**NOTICE OF A CONTINUED PUBLIC HEARING BEFORE
THE CITY COUNCIL ON AN APPEAL OF THE
PORTLAND DESIGN COMMISSION**

CASE FILE: LU 16-278621 DZM GW (Fremont Apartments)
WHEN: May 10, 2018, 2:00 pm
WHERE: COUNCIL CHAMBERS, 1221 SW FOURTH AVENUE

Site Address: **1650 NW NAITO PKWY**

proposed design revisions (plan view):

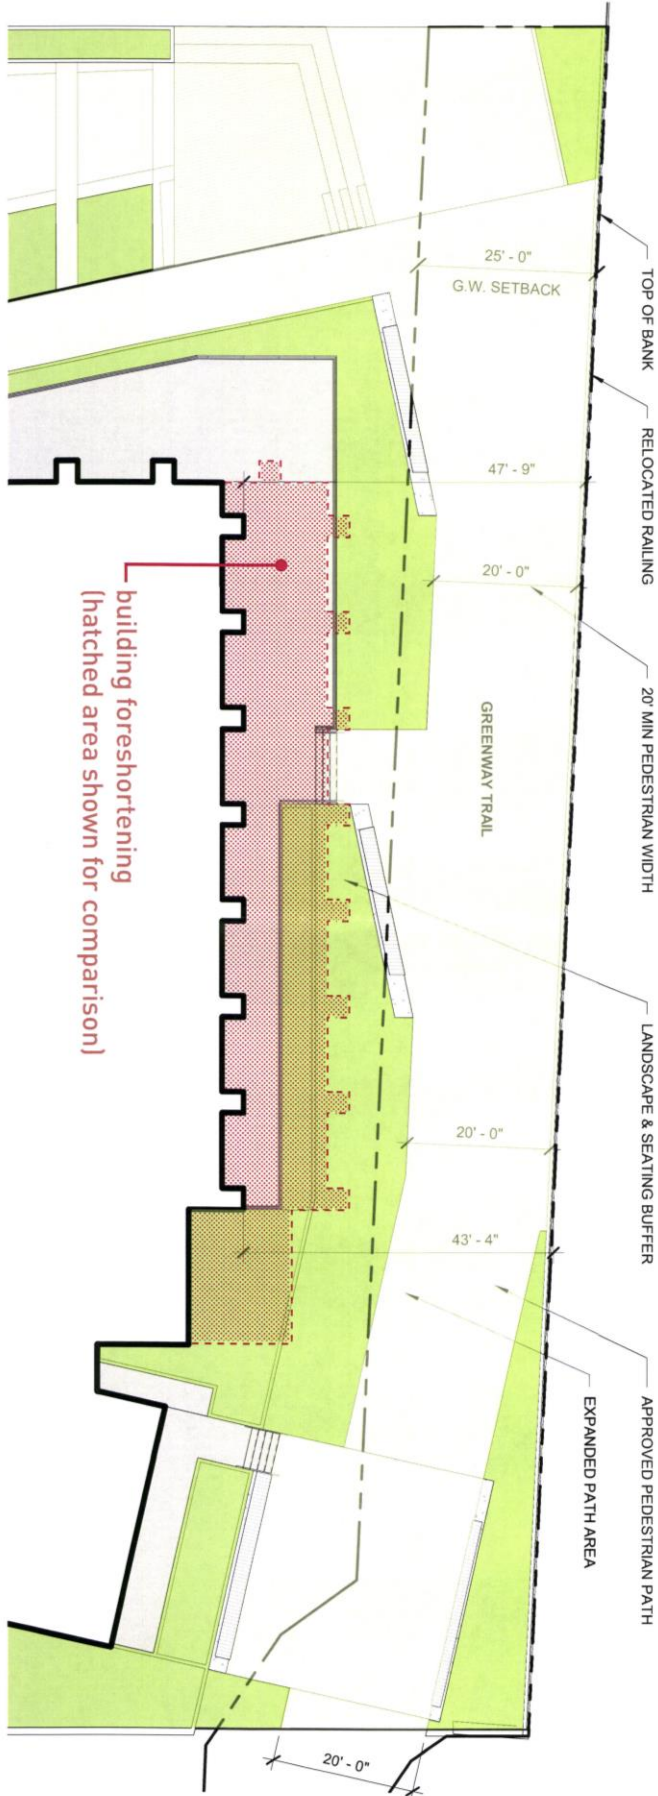
- The Greenway trail has been widened from a minimum dimension of 13'-0" to a minimum dimension of 20'-0" and redesigns some of the landscaping around the trail. The plaza on the north side of the site has also been slightly redesigned to accommodate the wider trail.

- We also moved the building 18 inches toward NW Naito Parkway by eliminating space between the building and the sidewalk and relocating our planters to the building wall.

12 appendix:
greenway section comparison

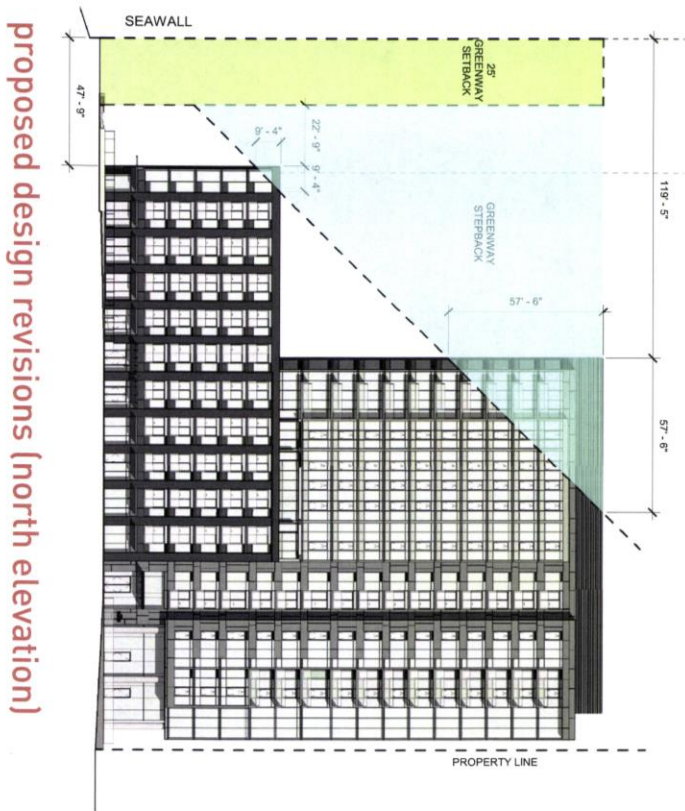
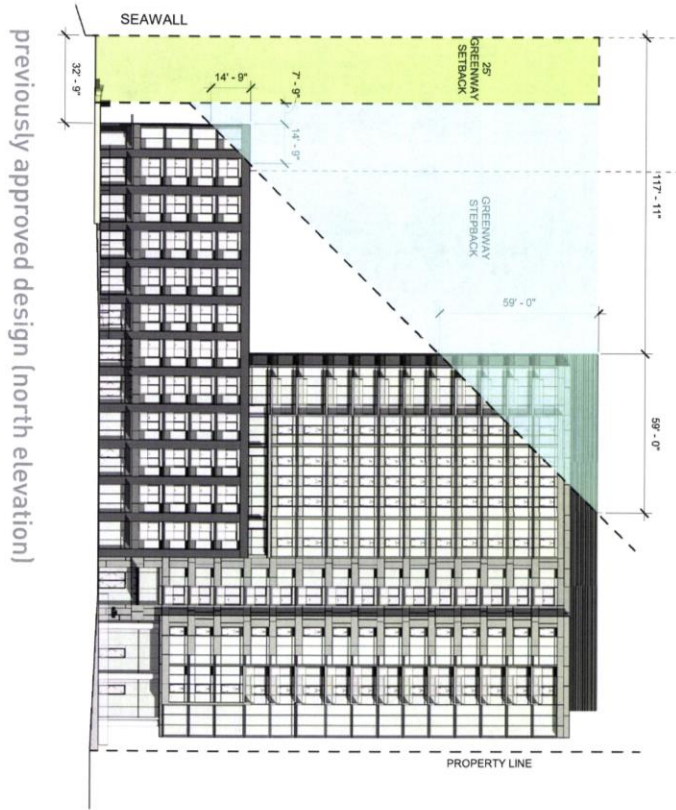
- The width of the bike/ped trail within the Greenway has been increased so it is now a minimum of 20 feet at its narrowest point – that increase makes it the widest Greenway trail section from South Waterfront to the terminus at Terminal One.
- Additional landscaping was added between the path and the building. This area now measures between 43 feet, 4 inches, and 47 feet, 9 inches from the seawall to building, almost twice the minimum size required by Code, and just about meets the new 50-foot setback standard under Central City 2035.
- A new public plaza has been added at the south end of the project. The plaza is envisioned to work in conjunction with the proposed new art studios to create a robust public arts area.
